Date	PC APP software:	BOB Firmware:	Donlight Firmware:	Github hash
07/07/2022	1.3.2 +Gerderla	+1.00.06	2.0.0	9c5dd7e6e79d4a 42567d73da661b cd3da96c2c06
	nd detup			Cusua90C2C00

Date	PC APP software:	BOB Firmware:		Donlight Firmware:	Github hash
13/07/202 2	1.3.2	+1.00.04		2.0.1	OdcOfd53f8bab6 O64ef1e388c6d3 fc15de7f900a
					V13.540V V2-960.0mV AV-4500V X1-960.0m AX-96.0m AX-96.0m B-46.90.0m

Date	PC APP software:	BOB Firmware:	Donlight Firmware:	Github hash
27/07/2022	1.3.3	+1.01.01(ping) +Programming bob firmware(39rev0) +BlueProgrammer firmware(38rev0)	2.0.2(ping)	c98619c3501752 e58b02ad9e8051 fafe462524e1

$13000003500_rev01_BOB_V01_00_05_hazardelaytoleranceUpto11ms$ is build on top of v01_00_04 with increased tolerance to delay in turning signals.

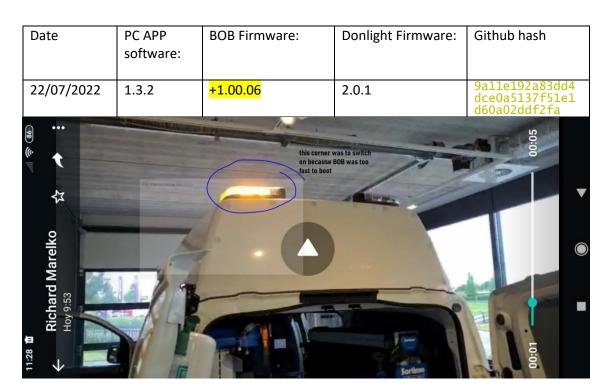
After spending 3hours with Richard at Gerderland and connecting the turning signals from the vehicle to an oscilloscope, we noticed this vehicle had a delay between turning signals of 9ms. As the BOB was set to tolerate delays up to 5ms between received turning signals the lights were glitching when the hazard was on.
